On behalf of my co-authors and myself, please accept our revised manuscript “**A combined use of in situ and satellite-derived observations to characterize surface hydrology and its variability in the Congo River Basin**” (HESS-2021-315) for consideration as a Research article to HESS.

Point-to-point replies to the review report

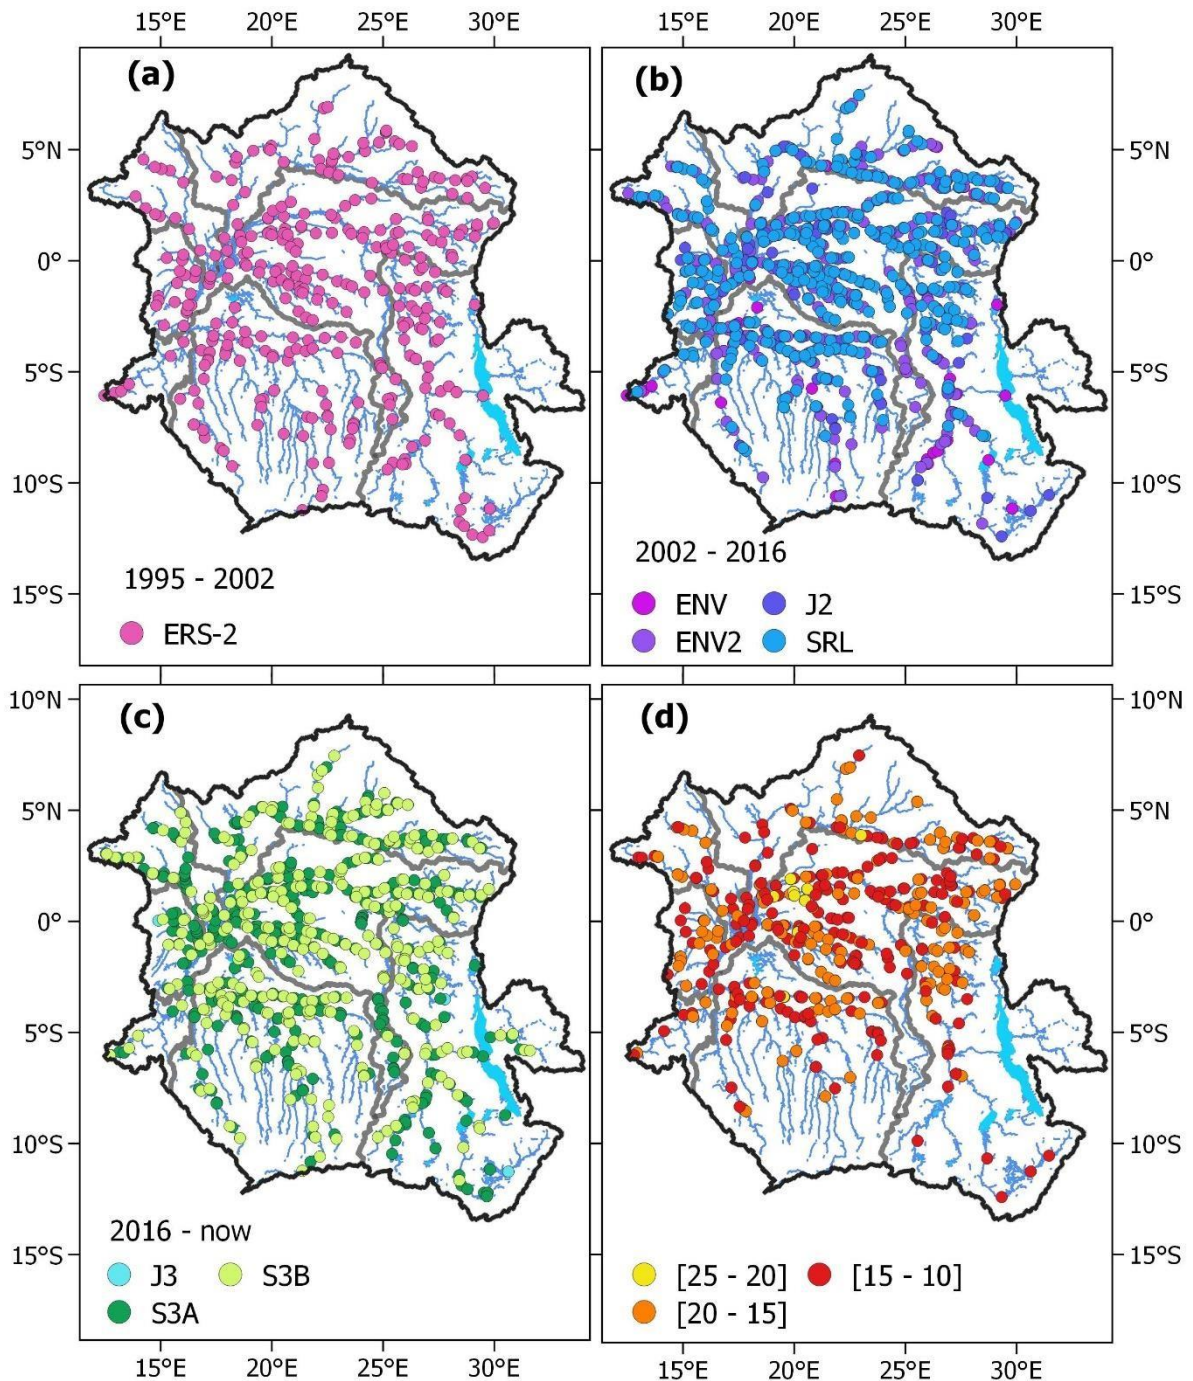
5. Figure 2(d): end bracket on the key seem to be the wrong way around. Should be [xxyy] instead of [xx-yy].

Our Reply: Following your suggestion, we have modified Figure 2(d) by changing the bracket. Figure 2(d) is now as follow:

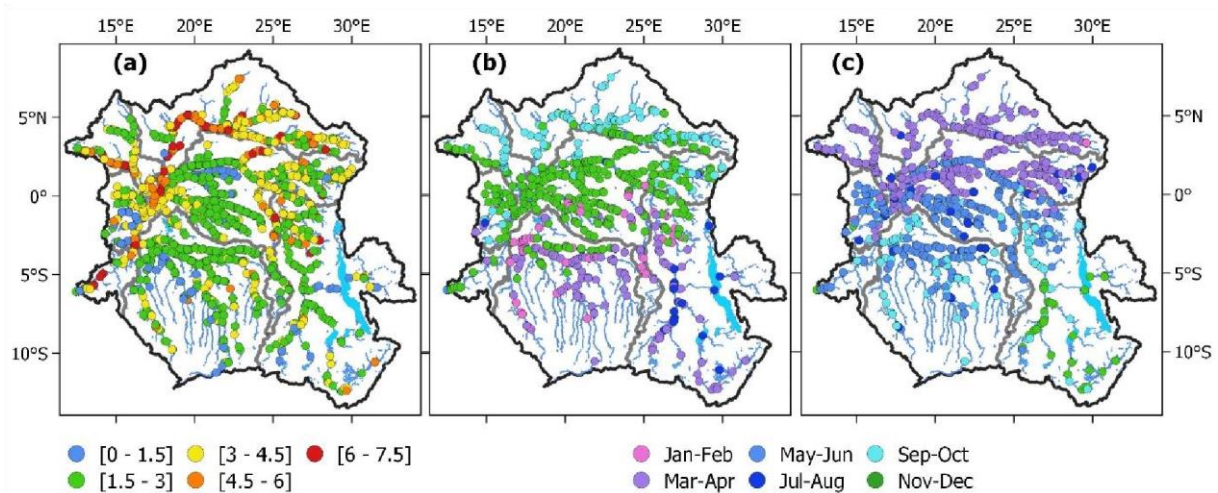
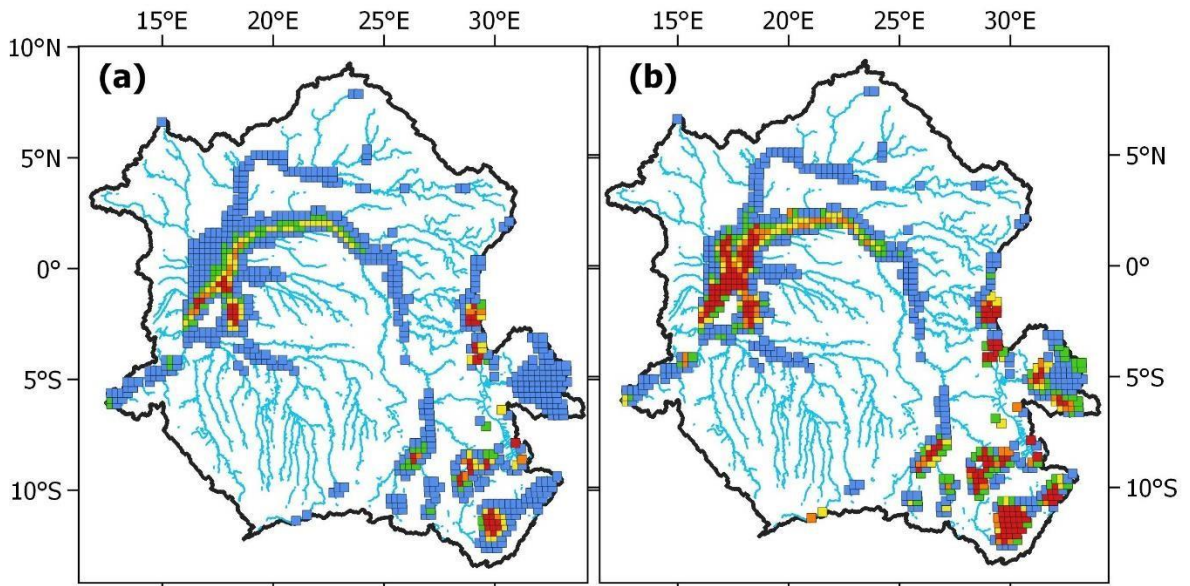
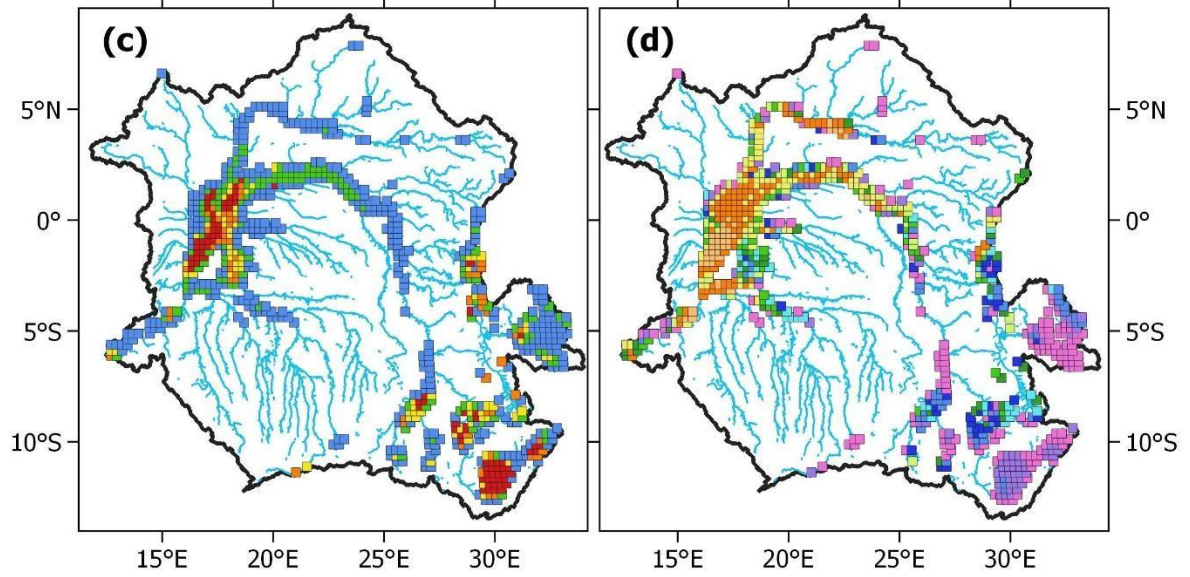
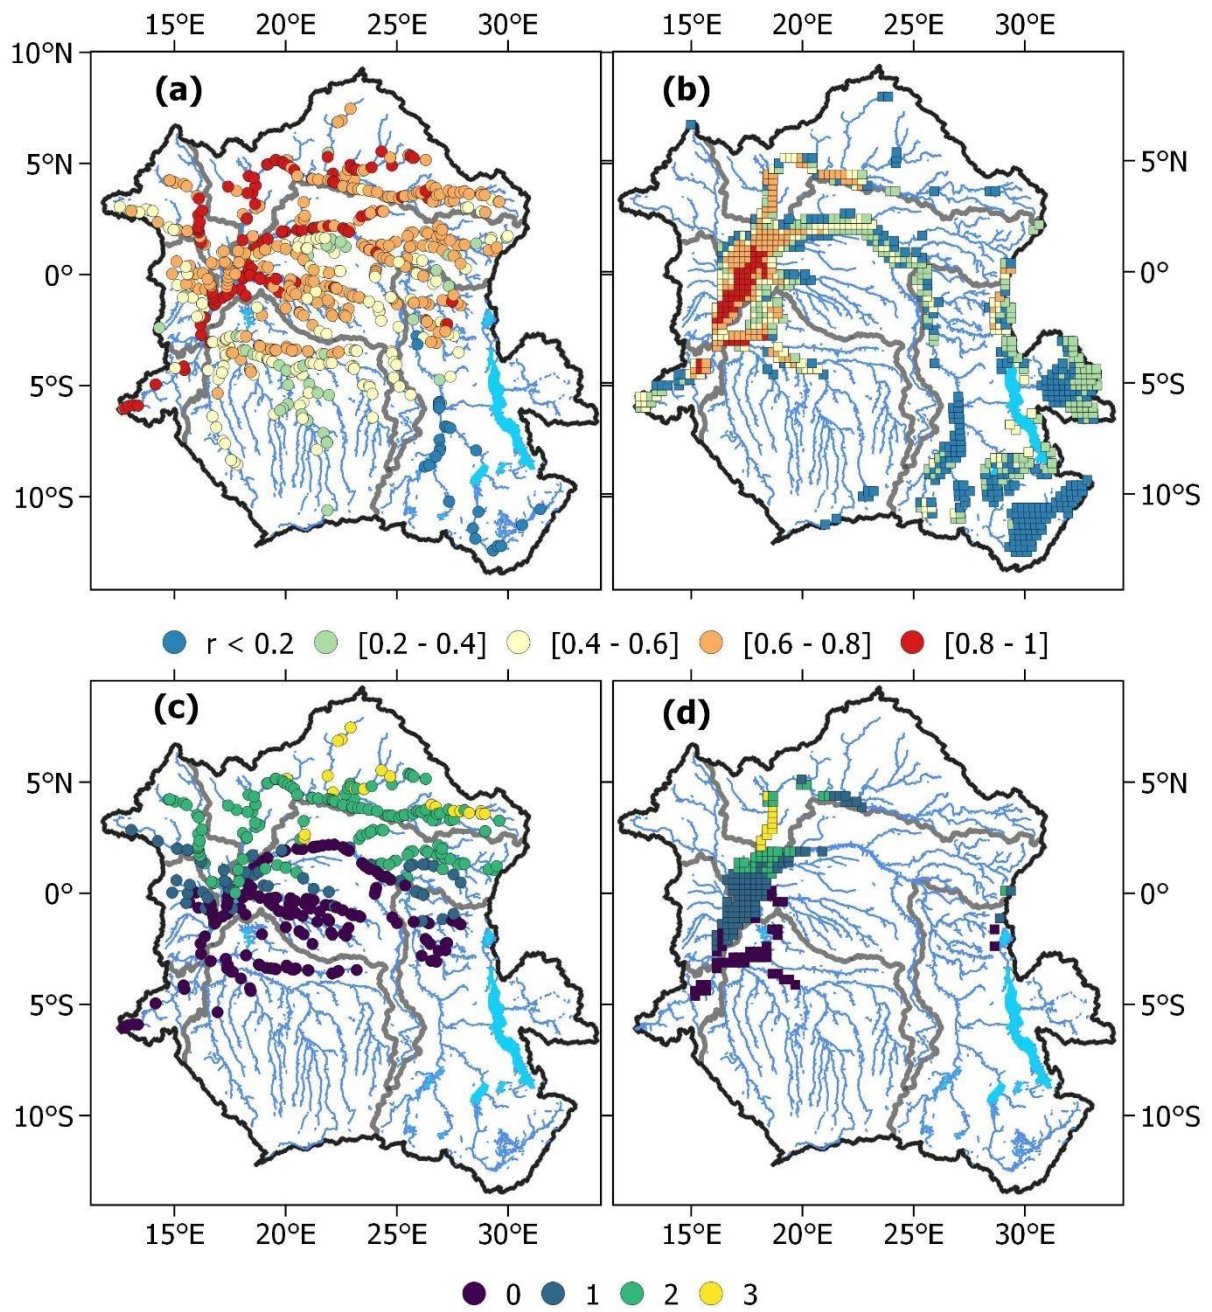
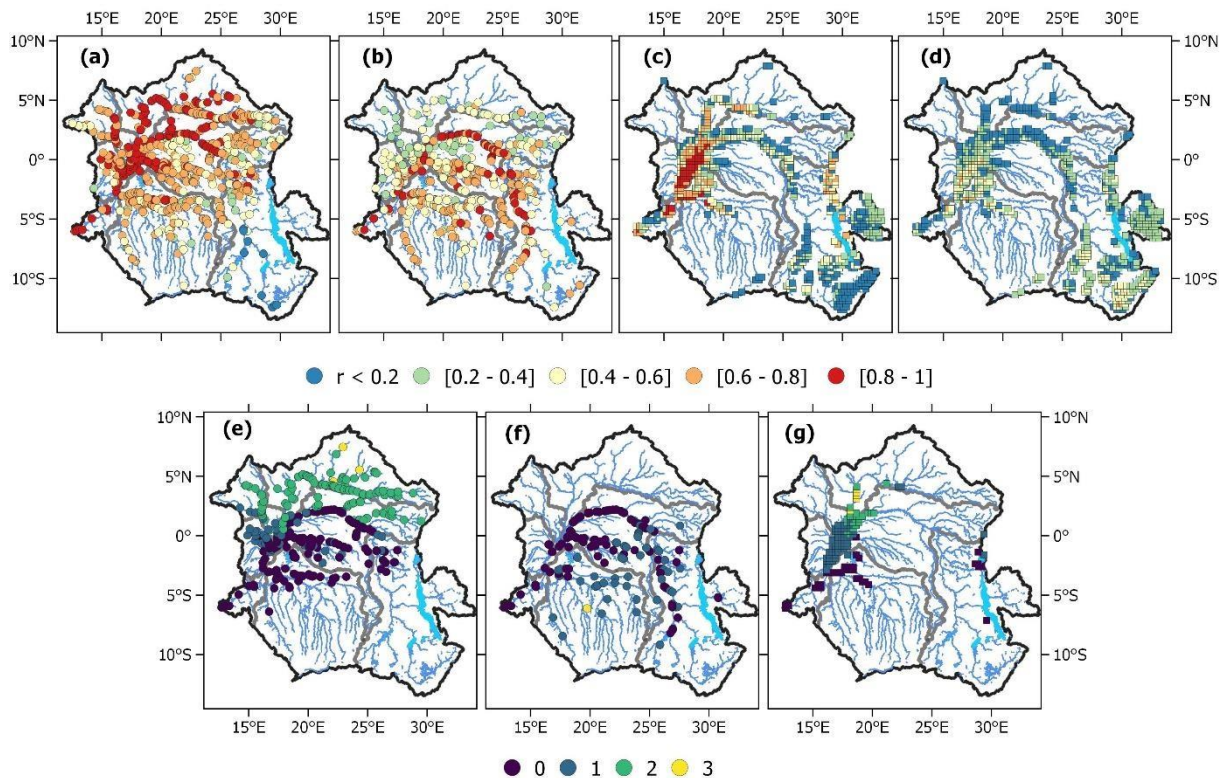
9. Figure 4(a) and Figure 5: end bracket on the key seem to be the wrong way around. Should be [xx-yy] instead of [xx-yy]. Please also check all other figures.

Our Reply: Following your comment, we have changed the bracket in all figures. Figure 4(a), figure 5(a,b,c), figure 9(a,b), and figure 10(a,b,c,d) are now as follow:

Please note that to improve the quality and clarity of our figures, the latter were all redesigned, and figures 3 and 7 were split each in two. Figure 3 has been split into figures 3 and 4, and figure 7 became figures 8 and 9. This change has been taken into account in the figure's numbering. Figure 4(a), figure 5(a,b,c), figure 9(a,b), and figure 10(a,b,c,d) became respectively Figure 5(a), figure 6(a,b,c), figure 11(a,b), and figure 12(a,b,c,d)
